BRIDGESTONE *by Rockford* Service Letter

BSG-0046 REVISED

BS/175 POINTS AND CONDENSER

MODEL BS/175

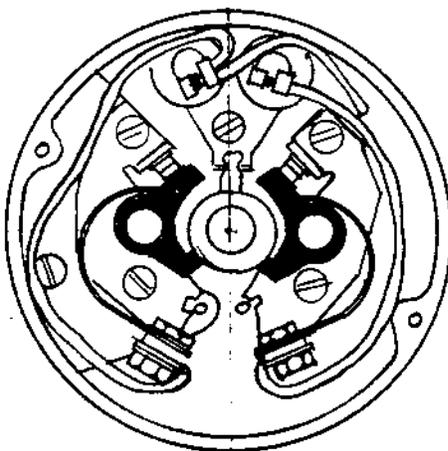
Shown below is an illustration of the generator with the cap removed to expose the points and condenser. This type of generator was used on all B/S 175 DT before Serial No. 16G-11760.

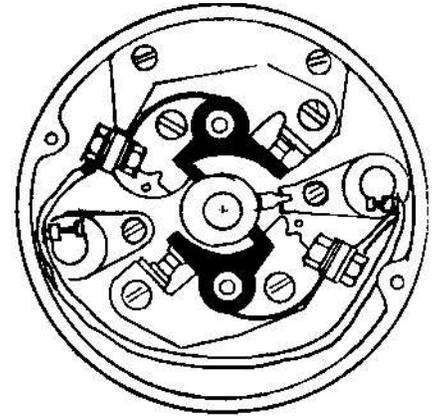
Shown below is an illustration of the generator with the cap removed to expose the points and condenser. This type of generator was used on all B/S 175 DT after Serial No. 16G-11761 up to Serial No. 16L-20757. This generator is also used on all B/S 175 HS beginning production up to Serial No. 16L-20757.

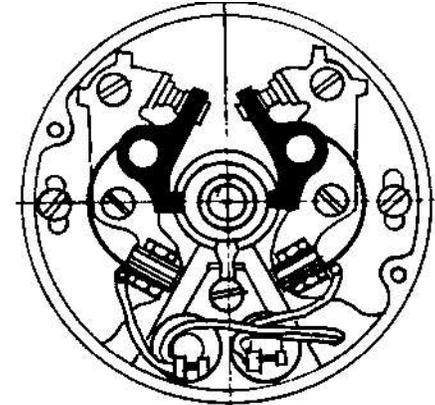
Shown below is an illustration of the generator with the cap removed to expose the points and condenser. This type of generator is used on all B/S 175 DT and B/S 175 HS after Serial No. 16L-20758.
